Access Compliance Report

Public Rights-of-Way

(Curb Ramps)

Intersection ID: N/A	Main Street: TRAILMOOR_RD	Cross Street: BRECKFIELD_CT	Location: SE
ADA ID: 0715A995EC5B	Ramp Type: PerpDiag	Initial Pass/Fail: Fail	Overall Compliance: No
Severity Score: 12.5			
Codes/Mitigation Info/Possible Solution		Field Measurements/Component Compliance

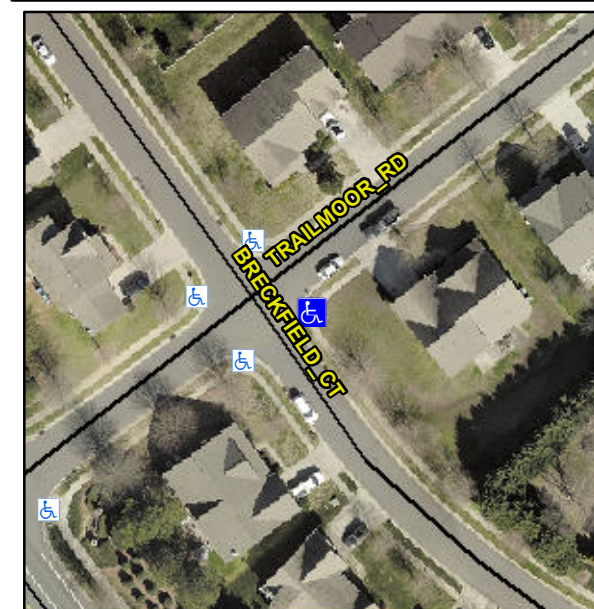
R304.2.2

Compliance	Description	Data	Compliance	Description	Data
N/A	Ramp Length (in)	48.0	No	Ramp Slope (%)	8.8
Yes	Ramp Width (in)	48.0	Yes	Ramp XSlope (%)	1.1
N/A	Flare Type LT	N/A	N/A	Flare Type RT	N/A
N/A	Flare Slope LT (%)	N/A	N/A	Flare Slope RT (%)	N/A
N/A	Flare Traversable LT?	N/A	N/A	Flare Traversable RT?	N/A
N/A	Landing Length (in)	N/A	N/A	DWS Provided?	N/A
N/A	Landing Width (in)	N/A	N/A	DWS Contrast?	N/A
N/A	Landing Slope (%)	N/A	N/A	DWS Length (in)	N/A
N/A	Landing X Slope (%)	N/A	N/A	DWS Full Width?	N/A
N/A	Landing Curb? (Y/N)	N/A	N/A	DWS Offset (in)	N/A
N/A	Shared Landing?	N/A			
N/A	Gutter Ponding?	N/A	N/A	Gutter Slope (%)	N/A
N/A	Gutter Lip Ht (in)	N/A	N/A	Gutter X Slope (%)	N/A
N/A	Painted X Walk1?	No	N/A	Painted X Walk2?	No
	X Walk 1 Direction	To NW		X Walk 2 Direction	To SW
N/A	X Walk 1 Width (in)	N/A	N/A	X Walk 2 Width (in)	N/A
	X Walk 1 Slope (%)	1.0		X Walk 2 Slope (%)	0.5
	X Walk 1 X Slope (%)	2.2		X Walk 2 X Slope (%)	0.6

Remove & Replace Curb Ramp With Two New Directional Ramps or Equivalent.
